# Building Code of Australia 2016 Amend 1

Summary Report for BCA Compliance

PROJECT NAME: Alex Avenue Public School

DATE: 28 February 2020

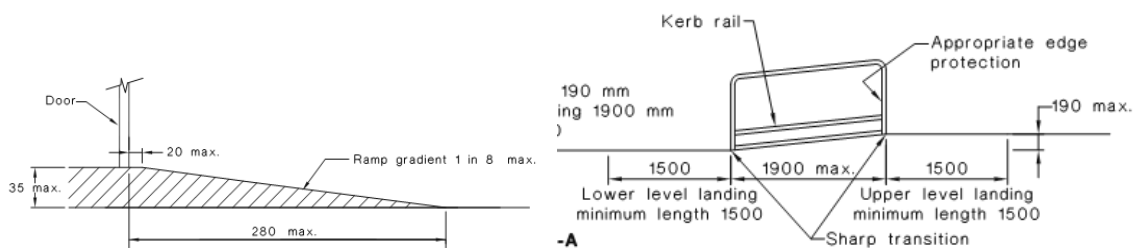
The BCA requires that any rooms or enclosures under non-fire isolated stairs to be enclosed in 60/60/60 FRL ( 1 hour) Fire rated construction of the walls and ceiling, and that any openings achieve the same fire rating, so the doors are to be swing doors, self-closing fire doors achieving a -/60/30 FRL and to AS 1905.1.

Note: being an FRL the fire rating is required in both directions, fire from above and fire from below, so just fire rated lining to the ceiling will not achieve compliance for example, needs fire rating on the top of the ceiling framing as well.

There are no Enclosures under the stairs identified on the plans, should these be proposed then the above requirements will apply.
